# Service Bulletin

Forward Fresh Air Ventilation System Retrofit

Document: Service Bulletin SB-GA8-2005-19

**Figure 1: Installation drawing showing the right forward side skin from inside the aircraft.**

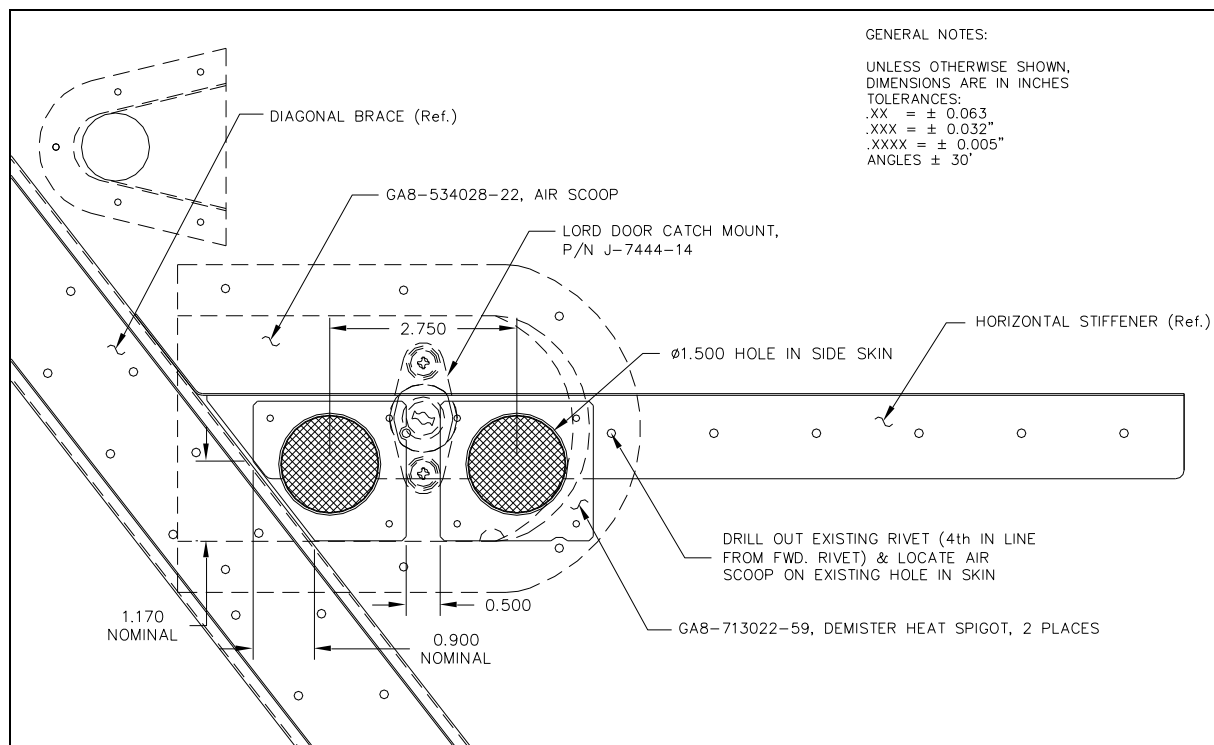
3. Disconnect existing SCAT6 ducts from their respective forward side vent assemblies, P/N GA8-534017-11.
4. Two spigots are to be attached to each of the left and right forward side skin, P/N GA8-534023- as per figure 1. Trim the forward spigot such that it will abut the horizontal stiffener, P/N GA8-534023-61(R)/-39(L) and the diagonal brace, GA8-534023-35 (from S/N GA8-00-004 up to and including S/N GA8-04-048) or P/N GA8-534023-83 (S/N GA8-04-049 and subsequent). Refer to figure 1 for key dimensions regarding spigot installation.

10. Locate the air scoop to the drilled out hole to the middle hole at the aft end of the air scoop.
11. Ensuring that the air scoop is level, drill 1/8" (#30 or 3.3mm) clearance holes through the air scoop and side skin as per figure 1. Temporarily secure the air scoop to the side skin.

15. Mark and drill 5/32" (#21 or 4.0mm) clearance holes in the side skin and install the Lord door catch mount in accordance with figures 1 and 2. Lord door catch mount may be further spaced with AN960-10 washers as required for flush finish with the air scoop.
